Outline Representation Sept 2021 :

A417 Missing Link at the Air Balloon
Response to
Highways England Supplementary Consultation
13th October - 12th November 2020

Gloucestershire Ramblers' Response to Ten Questions posed by Allan Pitt (Arup) to the Walking, Cycling and Horse Riding Technical Working Group (WCH TWG)

1. New crossings: Cotswold Way and Gloucestershire Way crossings

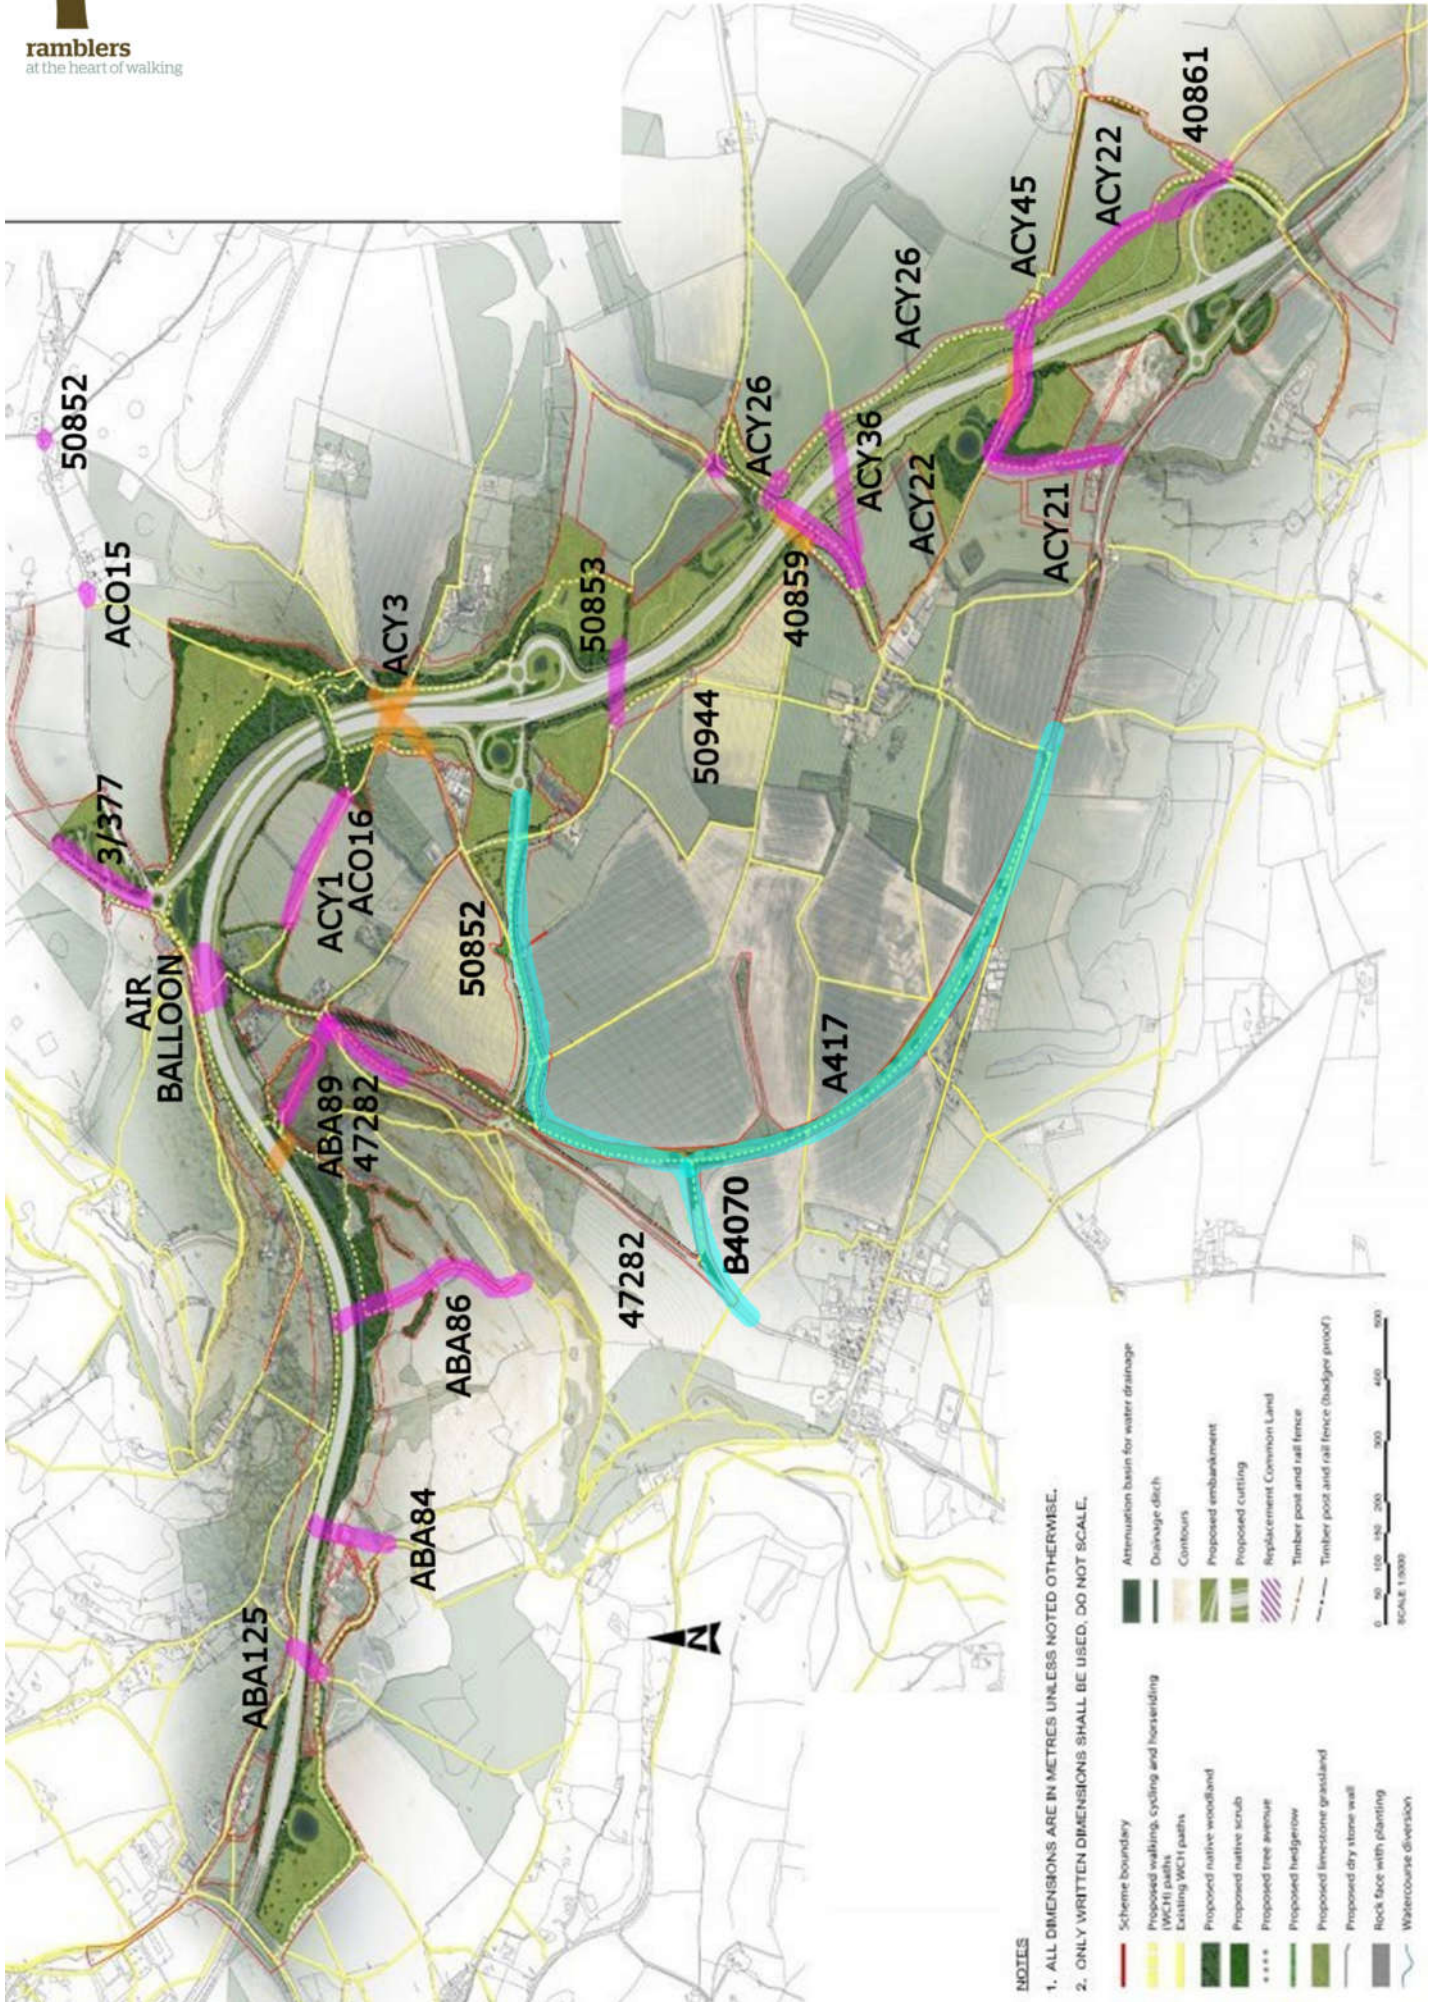
Ramblers strongly oppose these plans for a Cotswold Way Crossing.

It is welcome that an A417 crossing for the Cotswold Way and Gloucestershire Way is near its present alignment. However the design and materials and materials for the bridge are inappropriate for the location.

Ramblers could support proposals for a green bridge at the Air Balloon – as a landmark on both Trails.

2. The change in gradient of the A417 as it climbs the escarpment near Crickley Hill

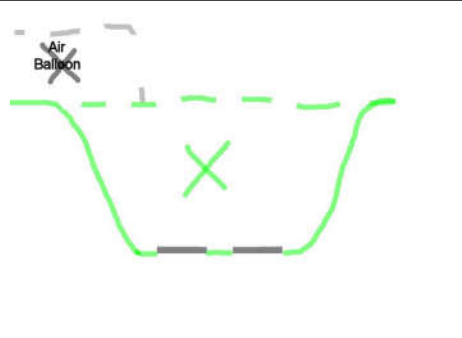
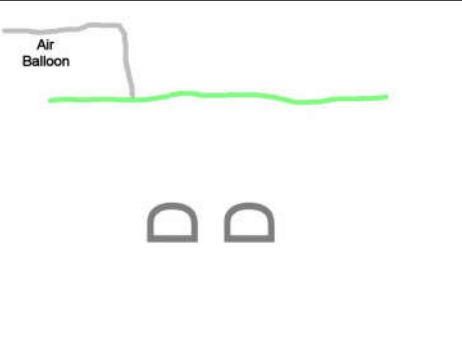
Ramblers oppose the increase in gradient as an overall benefit has not been demonstrated. Ramblers could support if there was demonstrable increase in crossings for paths and retention of the heritage and landscape of the area.

The quoted 10% is a peak gradient near the Air Balloon that would have been avoided by the scheme anyway. The proposed gradient of 8% is greater than the lower slopes of the present A417.

There is a step change in height of the landscape east of Grove Farm. A 1km tunnel between there and Shab Hill would have a maximum gradient of 6% and may not need a crawler lane.

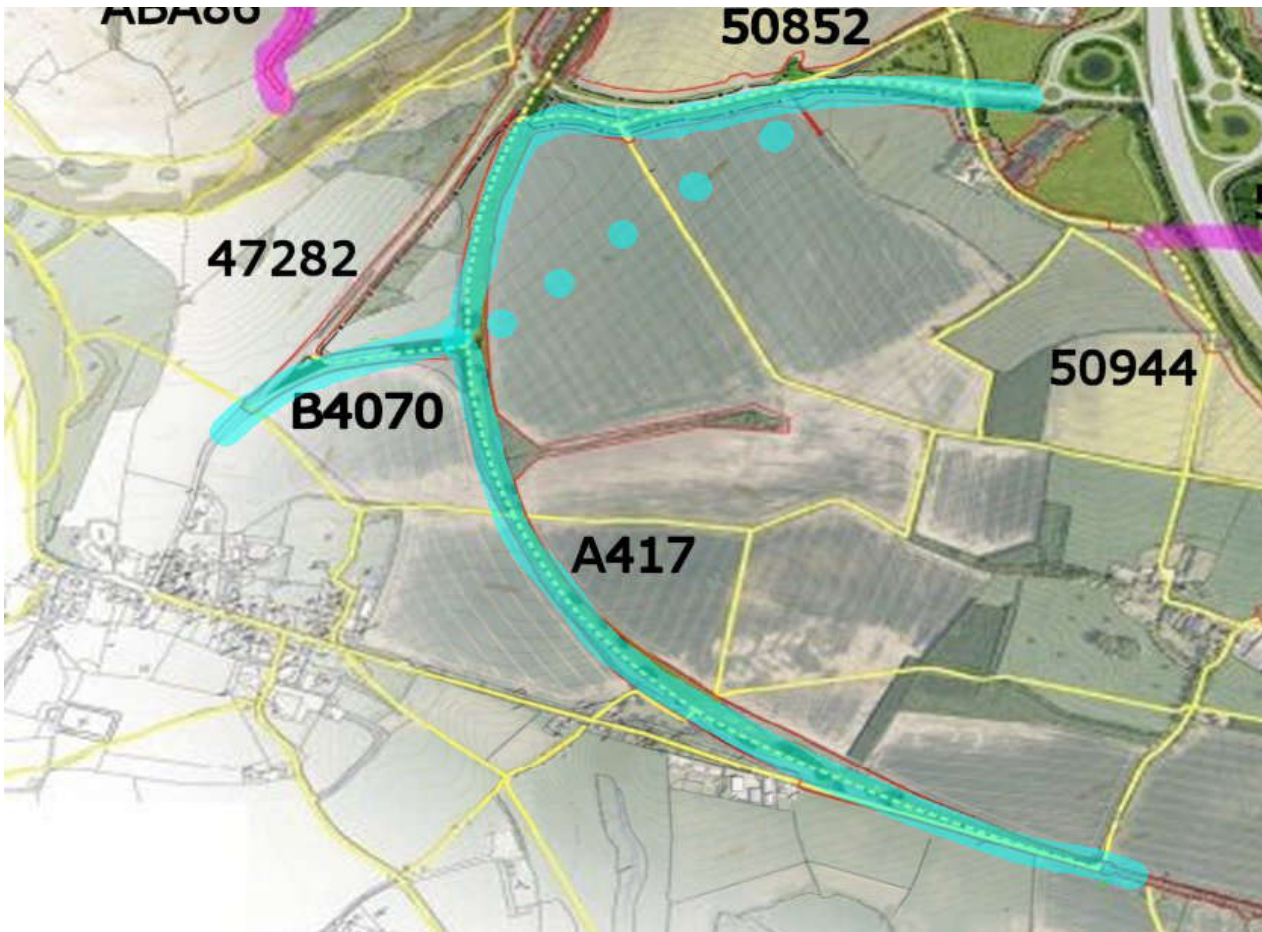
Ramblers Oppose the the new link road to Birdlip taking this quiet section of old road used for Walking Cycling and Riding. Ramblers could support another route for the link road away from this edge of the Escarpment.

The whole length of the existing road 42782 into Barrow Wake car park has good views from the edge of the escarpment. There are often 20-30 vehicles parked up either taking a break or for longer term parking for walks etc. If the proposal to use the road for the Birdlip link was to progress, these vehicles could fill up the Barrow Wake car park viewpoint.

These proposals take the Birdlip link road through the Barrow Wake underpass and install a roundabout at the view point car park entrance. The quiet walking and cycling road 50852 to Shab Hill is to be repurposed as the link between the new A417 and Birdlip village.

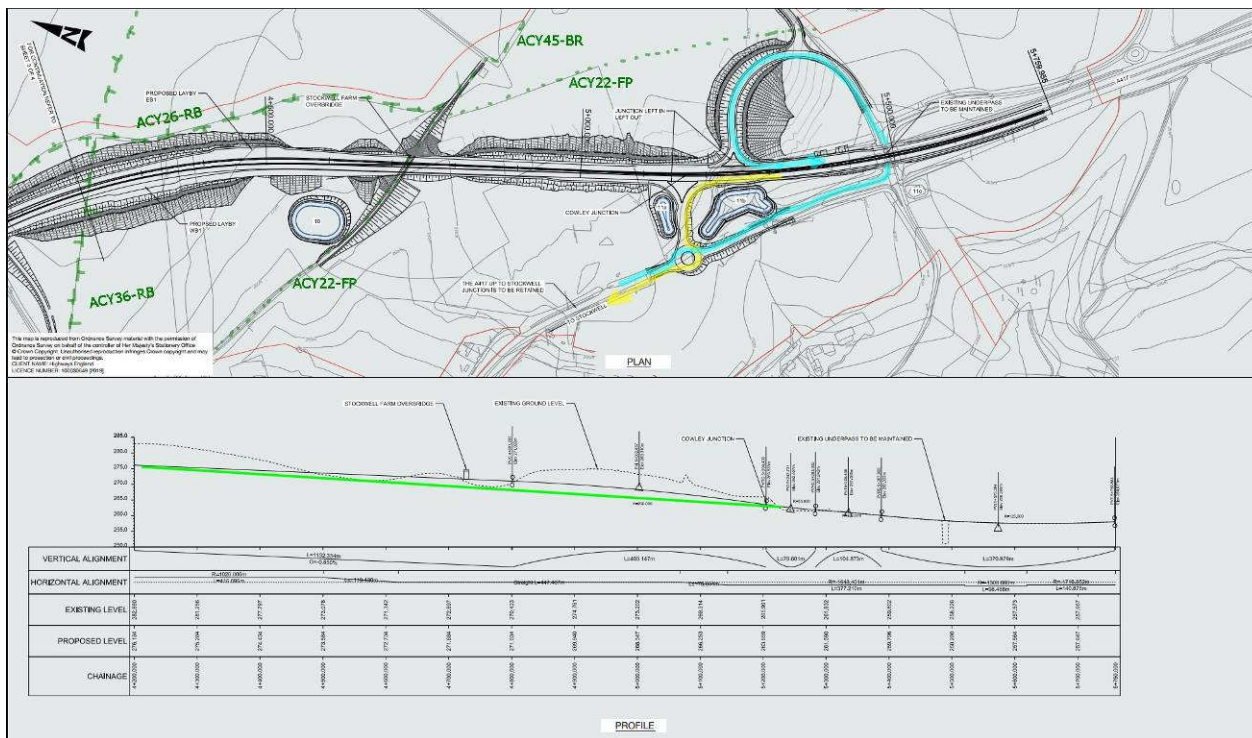
The map image right overlays option 30 onto an OS map. An avenue of lime trees heads north east from Stockwell Farm either side of the current lane. Highways England proposal is to break a small road through the lime trees, build a bridge in parallel with the current lane, then demolish some of the rest of the avenue with the new dual carriageway. The previous flythrough video image shows new trees planted on the flanks of the new bridge i.e. not inline with current.

An option here would be to build the new bridge on line within the lime trees where possible and replant new or reuse trees in line with the present ones.

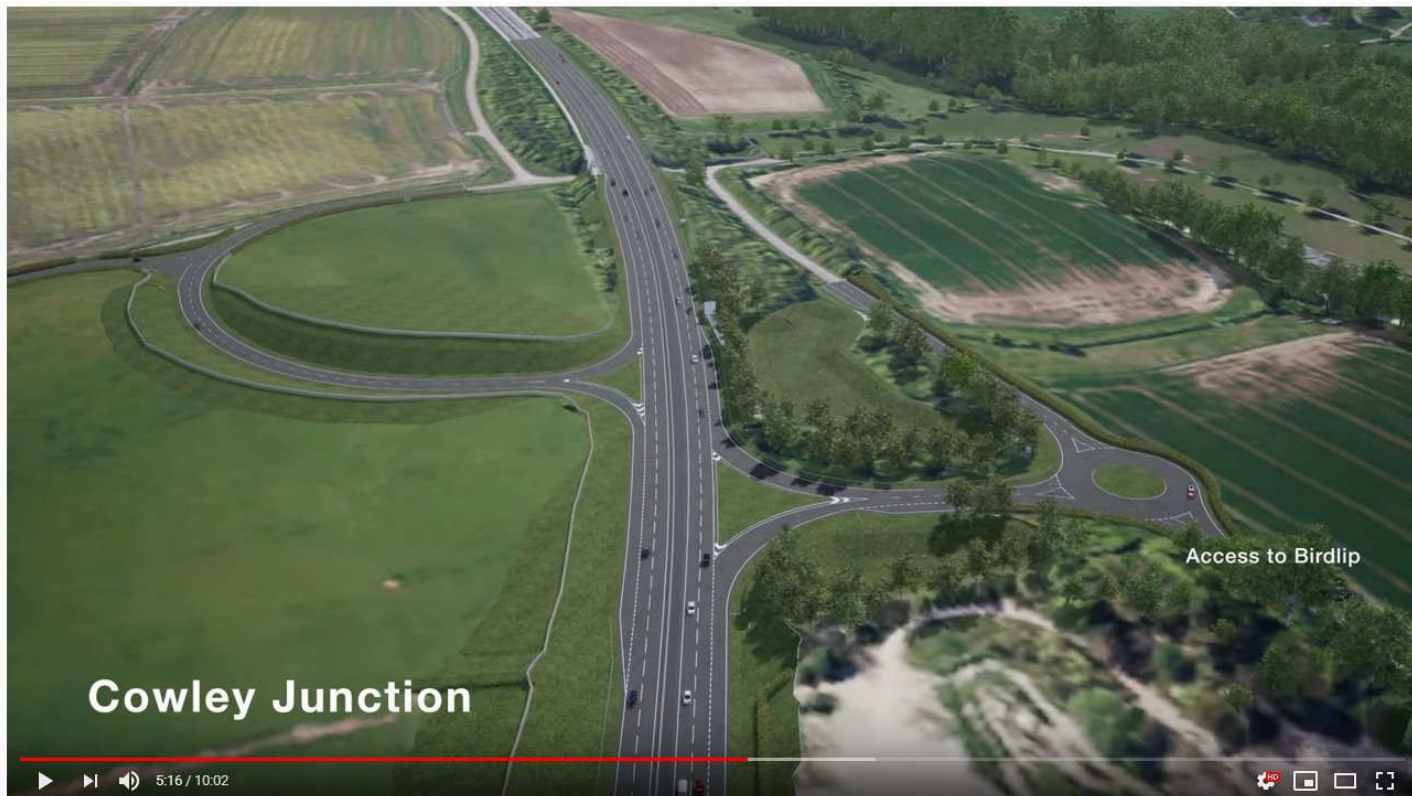
Below the proposed bridge for Stockwell Lane farm track marked as a footpath ACY22. The quarry can be seen off to the right and just in front of the bridge the present line of the track. The footpath is historically wide – some 10 metres. A green flanked bridge here could have planted hedgerows either side to retain the enjoyment of the path.

Cowley Junction

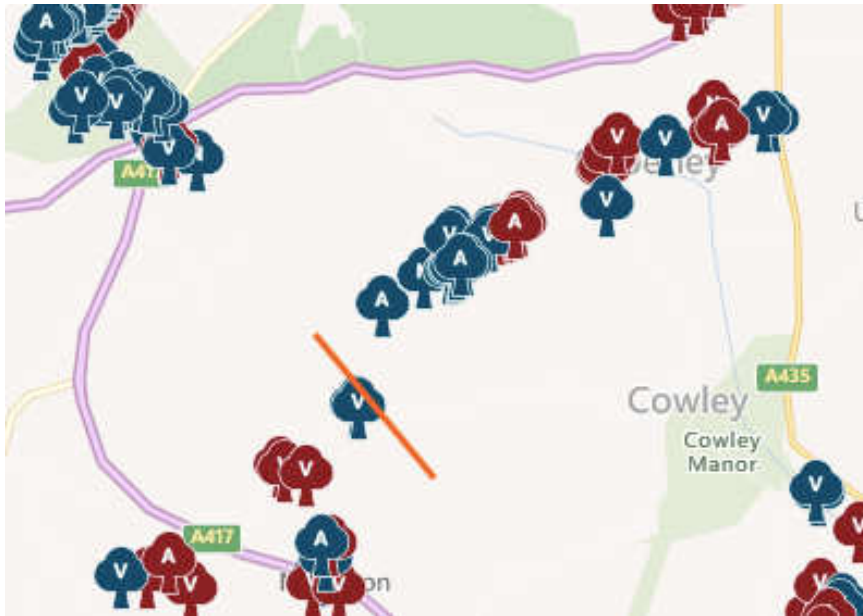
The video caption to the right says there is 'Access to Birdlip' from this junction (for local traffic). However Highways England proposal suggests closure of the road to all traffic from the Stockwell Farm Cowley Lane junction onwards.

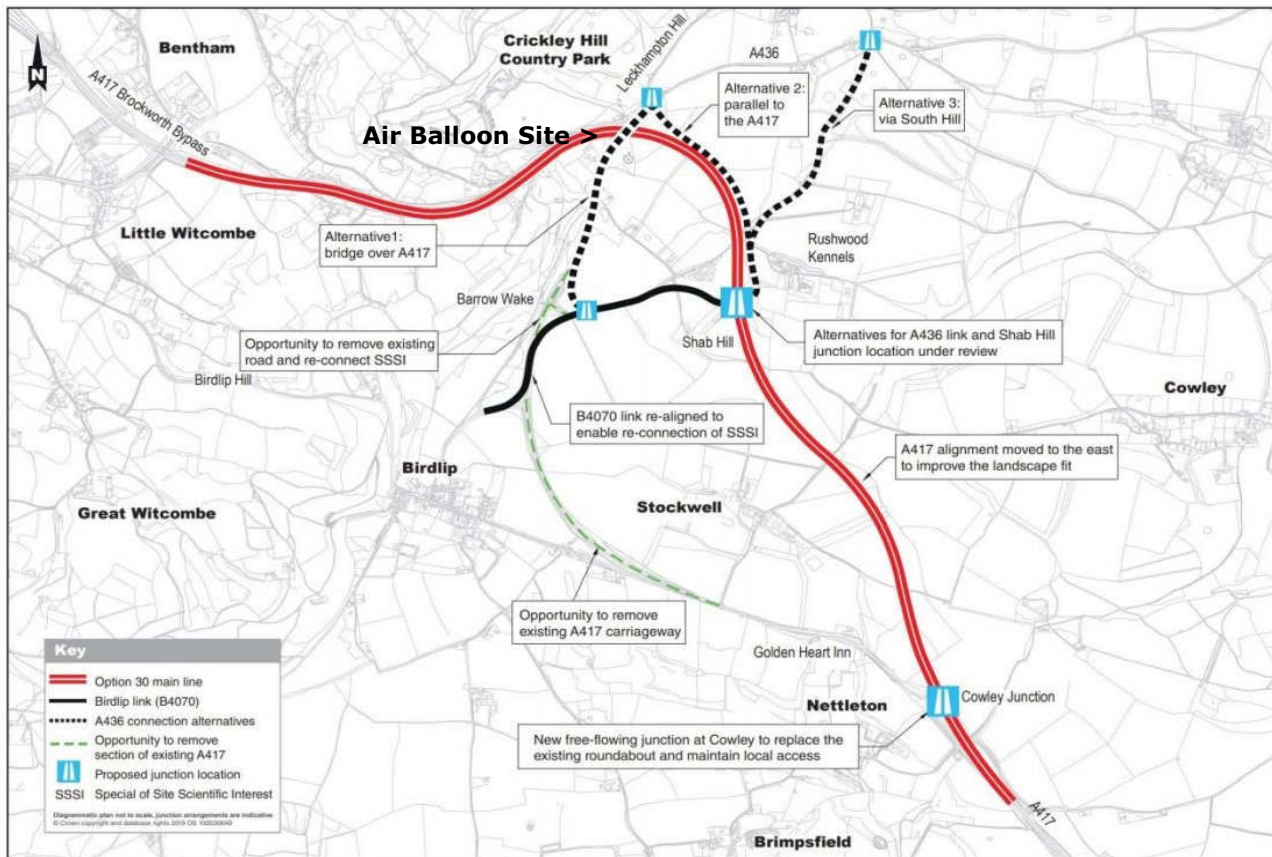
The current A417 should be retained for local traffic from Birdlip village to the Golden Heart Inn. The remaining section of the carriageway, from the current Birdlip / Stroud junction to the Air Balloon, should be stopped up to motorised traffic, except for traffic requiring access to the property "Crickley Ridge", and nature allowed to take its course in reclaiming the land. Subject to the needs of the SSSI, the resources that would have been spent on "re-purposing" the old carriageway should be focussed on providing additional bridges over the new road.
